## SUMMARY OF CONCERNS IN RELATION TO THE PROPOSED NORTHCONNEX TUNNEL

**This is an objection to many aspects of the proposed NorthConnex tunnel.**

## SECTION A: THE CONNECTIVITY OF NORTHCONNEX SOUTHERN VENTILATION FACILITY AT THE SOUTHERN INTERCHANGE, THE SOUTHBOUND TUNNEL IN PARTICULAR

Figure 5-17 Motorway operations complex

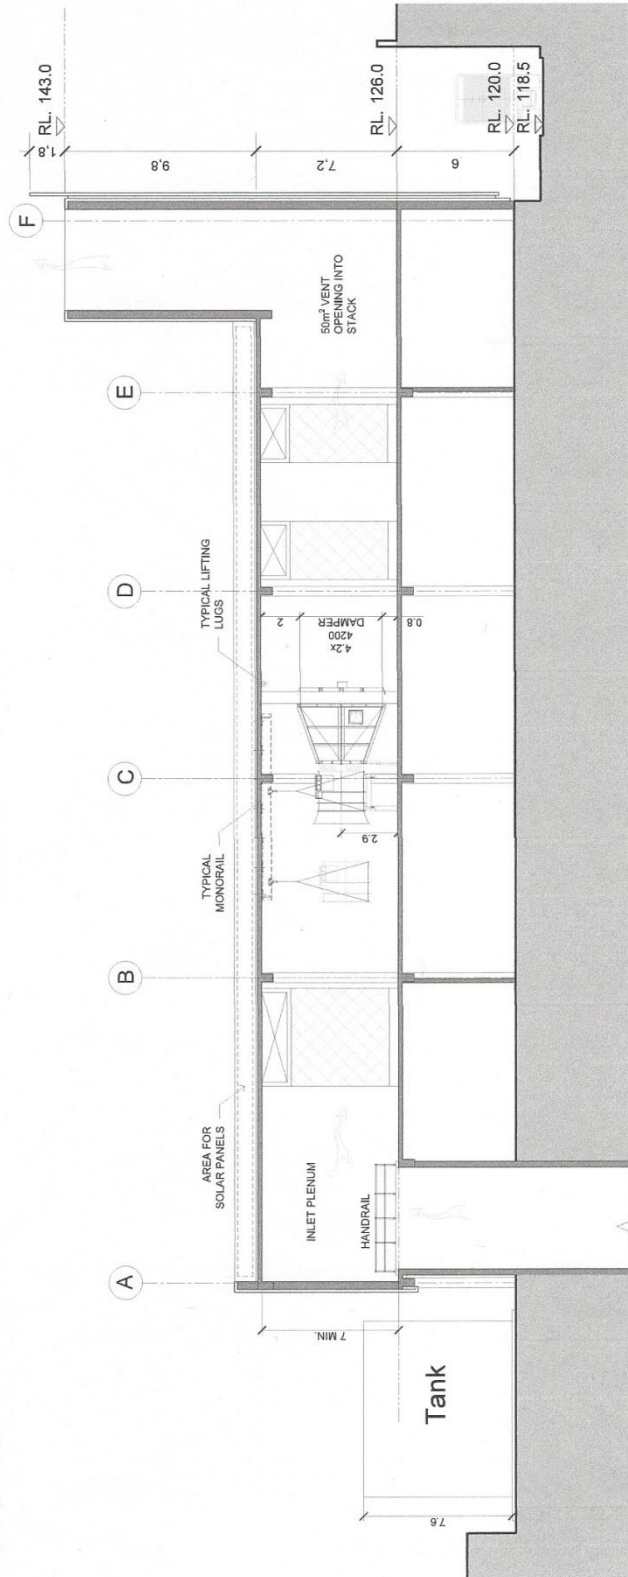
EIS Page 111, *Figure 5-17 Motorway operations complex*

*Page 8 below* there is no indication of how the ventilation facility will be connected to either the northbound or southbound tunnel, nor is there any indication of how the southbound exit portal onto Pennant Hills Road or the south-west exit portal onto the M2 will be connected.

- Diagrams need to be provided showing the inter-relation between the shaft, the ventilation outlet and the motorway operations centre with a clear description of what is to be constructed and how it will operate.
- The community needs irrefutable evidence that the polluted air from the southbound tunnel exit portals will not be allowed to flow like an invisible sewer through West Pennant Hills, North Rocks, Carlingford and Beecroft.

MOTORWAY OPERATIONS COMPLEX - SOUTHERN VENTILATION FACILITY - SECTIONS  
M1-M2-5000-DR-JD-0525

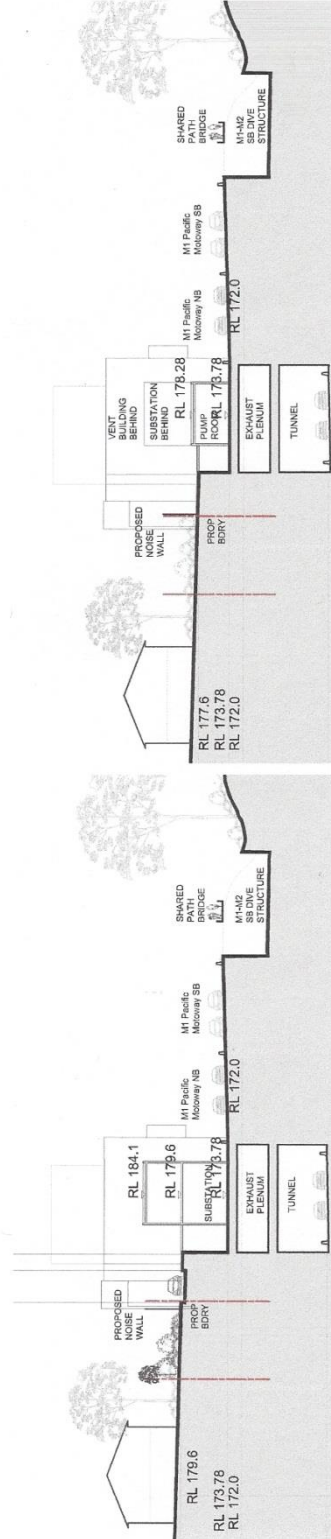
5. *EIS Volume 4, Technical working papers - Urban Design, 6.0 Operational Ancillary Facilities*  
EIS Page 99 there is the diagram "Motorway Operations Complex – Southern Ventilation Facility – sections. *Page 10 below* The diagram has the cryptic label "Connection to tunnel TBC". What does TBC stand for? To be considered? Why is tunnel singular? Which tunnel is the diagram referring to northbound or southbound? There is no diagram showing any connection from the Southern Interchange ventilation facility to either the northbound or the southbound tunnel in any way AND YET ....

6. *EIS Volume 4, Technical working papers Urban Design, 8.0 Landscape Design*  
EIS Page 176 is the diagram "Motorway Operations Complex – Southern Ventilation Facility – Site 1-1". *Page 13 below* The diagram does not show any connection to either the northbound or southbound tunnel. In the same Landscape Design section, EIS Page 182 is the diagram "Wilson Road Tunnel Support Facility –Section" *Page 14 below* which clearly shows the connection to the tunnels. In the same Landscape Design section, EIS Page 189 is the diagram "Northern Ventilation Facility – Landscape Concept Section". *Page 15 below* This also clearly shows the connection to the tunnels.
